SUBJECT: SYSTEMATIC EVALUATION PROGRAM TOPIC III-7.A., INSERVICE
INSPECTION INCLUDING PRESTRESSED CONCRETE CONTAINMENTS
WITH EITHER GROUTED OR UNGROUTED TENDONS - PALISADES

PALISADES
SYSTEMATIC EVALUATION PROGRAM BRANCH
TOPIC III-7.A

TOPIC III-7.A INSERVICE INSPECTION INCLUDING PRESTRESSED CONCRETE
CONTAINMENTS WITH EITHER GROUTED OR UNGROUTED TENDONS

FIGURE 5-1 Average Normalized Tendon Force vs. Time - Hoop Tendons

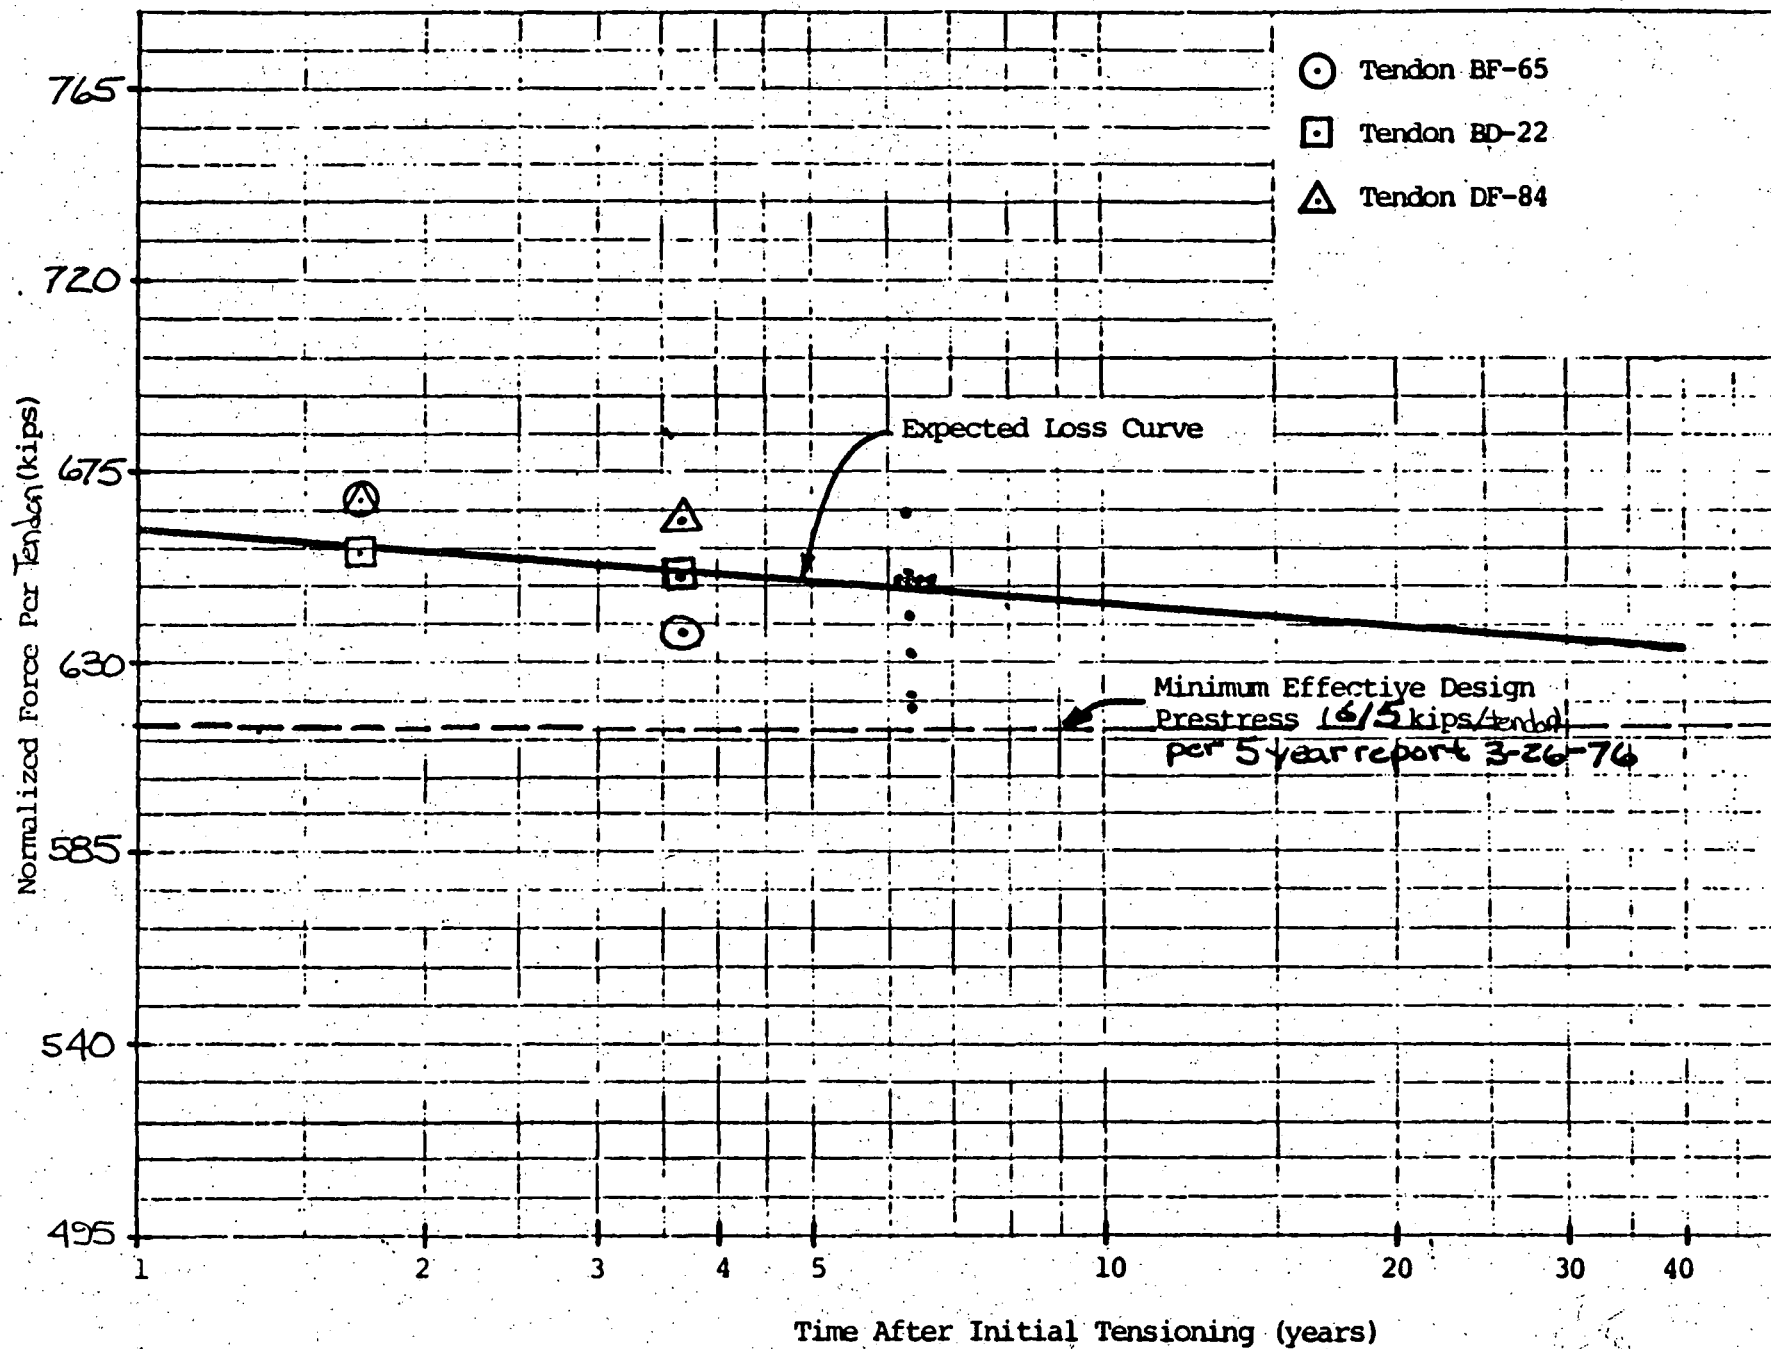
The results of the one, three, five year and any future inspections should be included on these graphs. The graphs should show tendon force not wire force versus time for reasons given in the evaluation. The staff has done this from some of the values and shown them in the attached Figures 5-1, 5-2, 5-3. A normalization factor of 0.97 was assumed for the five year test data by averaging previously given normalization factors for other tendons which had never been liftoff tested. Also, the three year values for vertical tendon which were concluded to be questionable due to method of testing were not included.

The graphs to be prepared by the licensee should use actual calculated normalization factors excluding the term to account for missing wires.

Acceptance criteria should be established which vary with time. An acceptable method for future inspections would be to specify upper and lower acceptance limits for tendon forces which vary with time, envelope the expected loss curve, and maintain the lower limit above the minimum effective design prestress. Current plant technical specifications should be changed to reflect this.

FIGURE 5-3 Average Normalized Tendon Force vs. Time - Dome Tendons

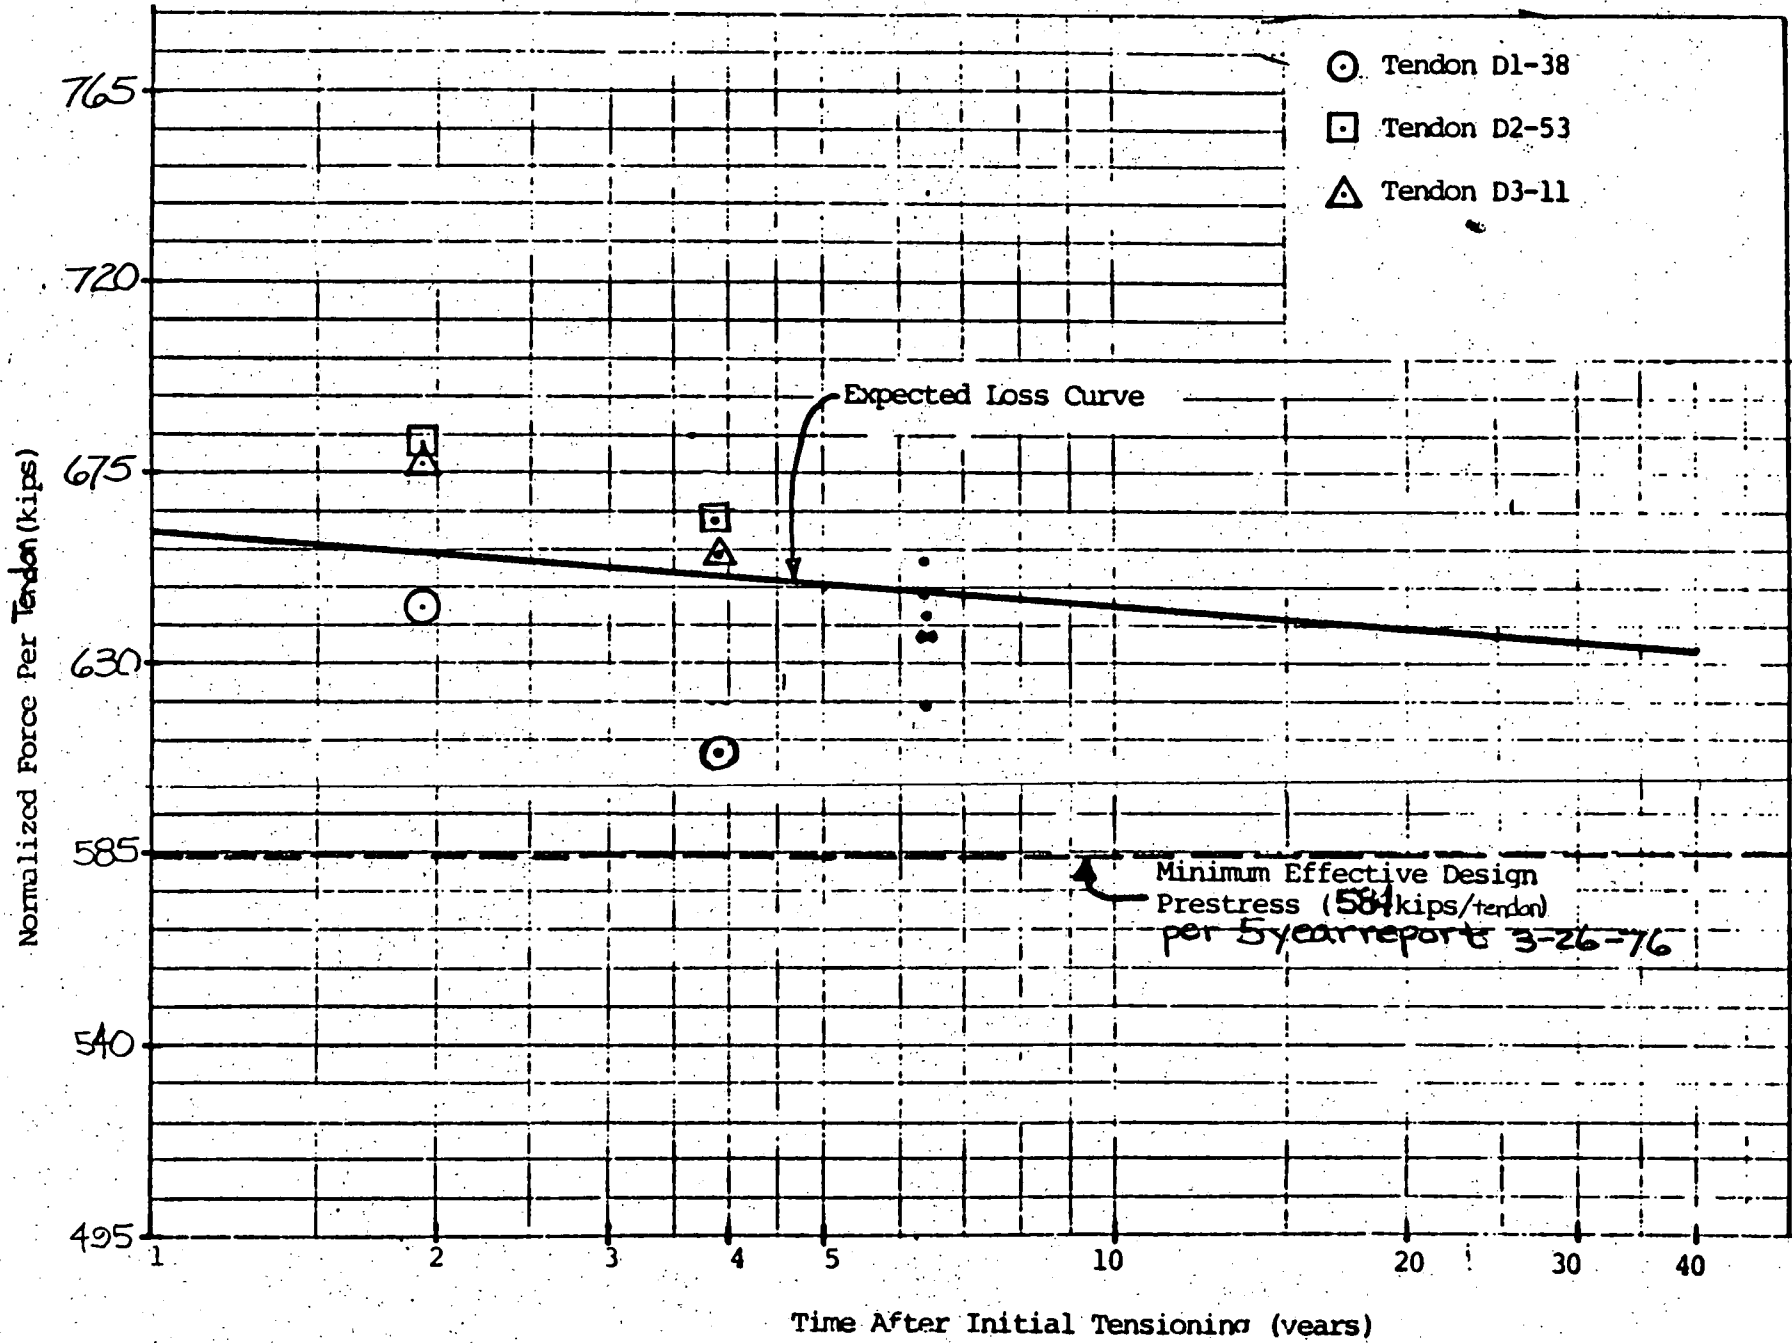
In addition to the random tendons required to be inspected during the ten year test per Regulatory Guide 1.35, Revision 2, tendons BF-65, DL-38 and one additional dome tendon selected at random should be tested for liftoff. BF-65 and DI-38 appear to be losing prestress at a substantially

faster rate than expected. Even viewing one and three year dome tendon results with caution, it appears that dome tendons may be losing prestress faster than predicted. This would be even more likely if the one and three year results were actually higher than shown as they very likely would be had the 5 year testing method been used. Testing these additional dome tendons would increase the data base to determine if this is really the case.
